Modify date	Project:	Archambault 35 replacement rudder & bearings RUD33R	
Modify date			
Modify date	Scale	1:12	Date 22–11–2016
Modify date	Material	AISI630	Drawing no. .
Modify date	Filename (dwg)	Archambault 35_replacement_JEFA–V2	
Modify date	Drawn by	A.G.

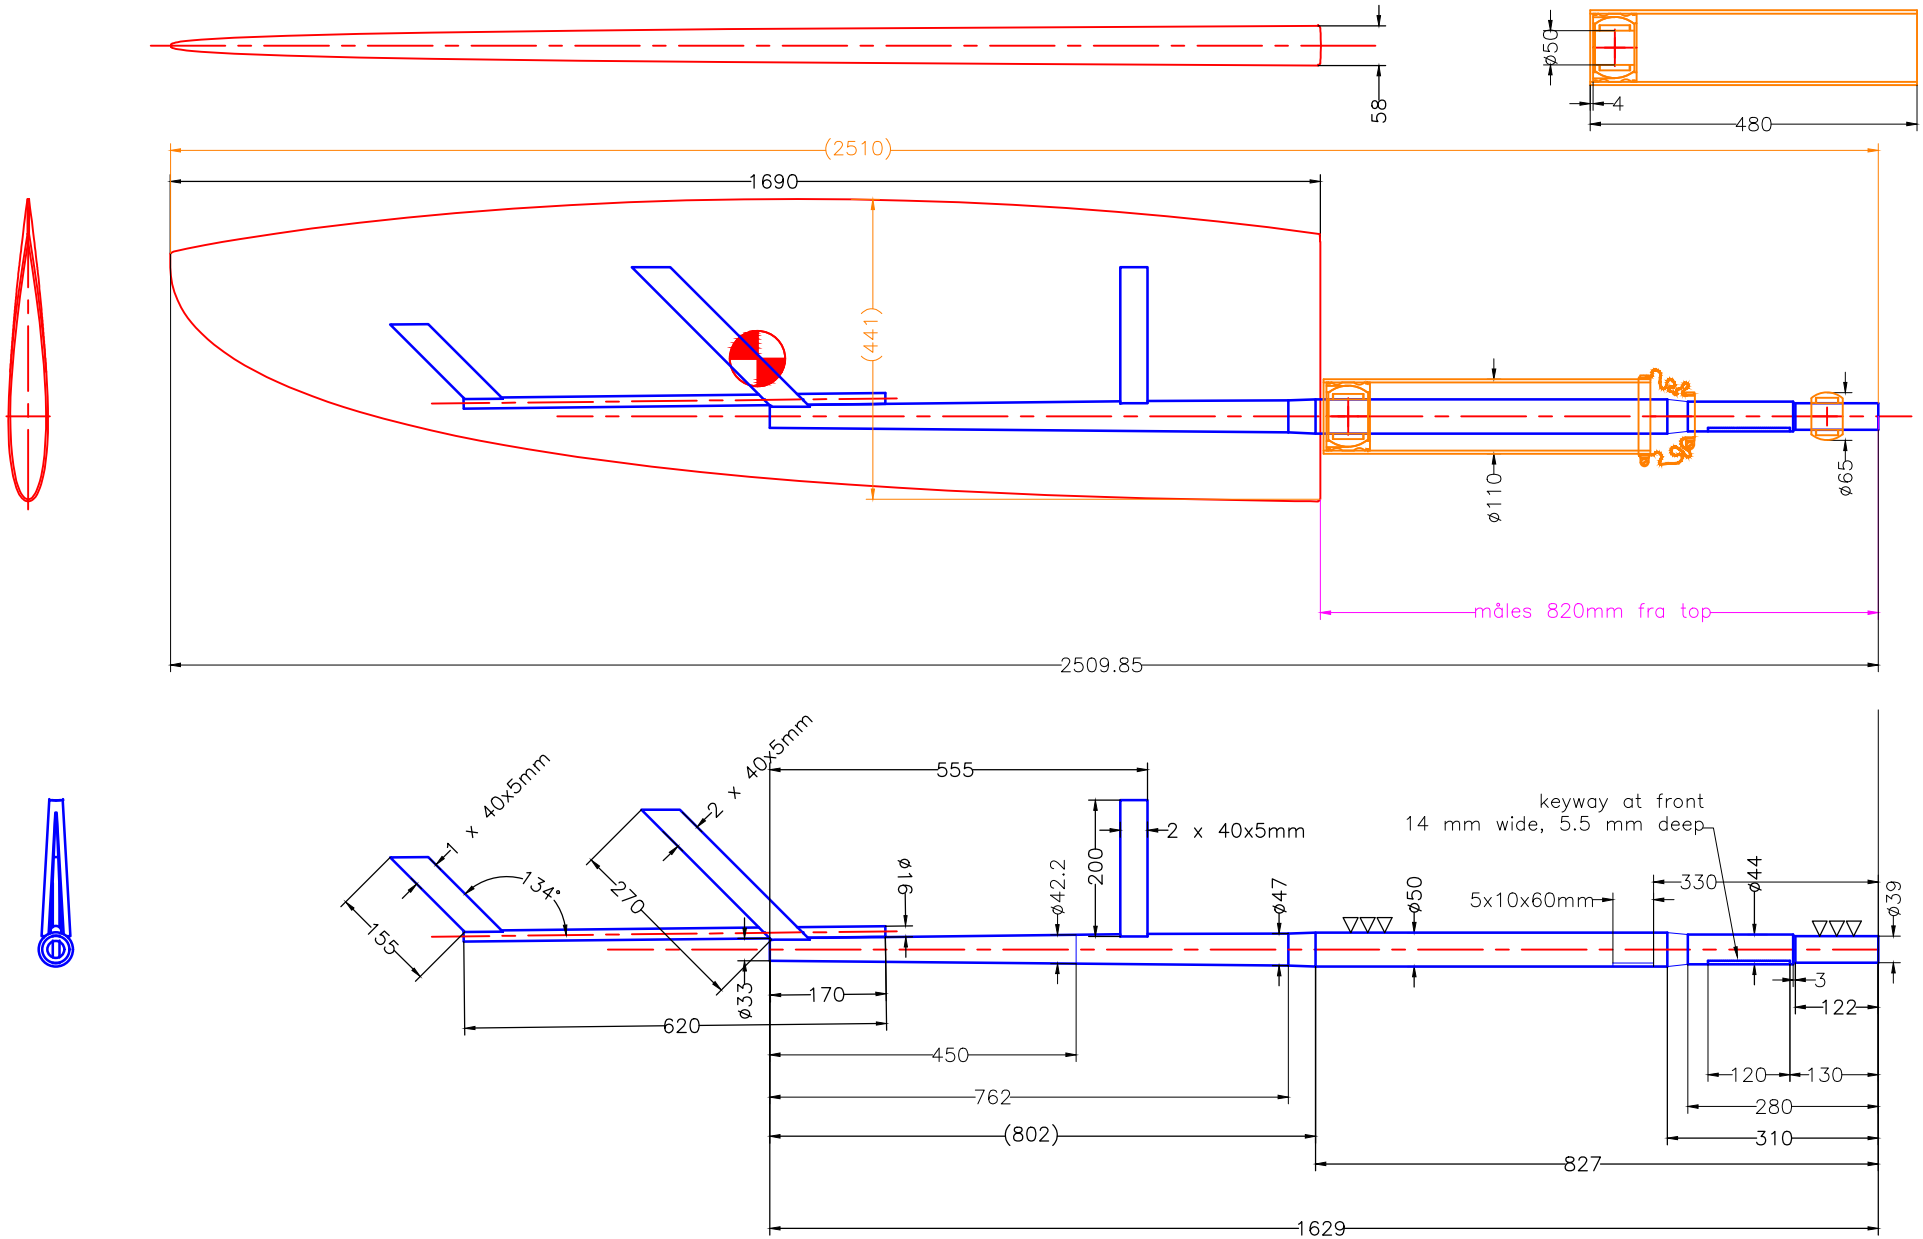
NB: the original rudderstock is Ø44, which is too small and can break under high load. The replacement rudder stock is Ø50 mm which doesn't fit in the original bearing. So the original bearing has to be sawn out and the GRP tube has to be laminated in.
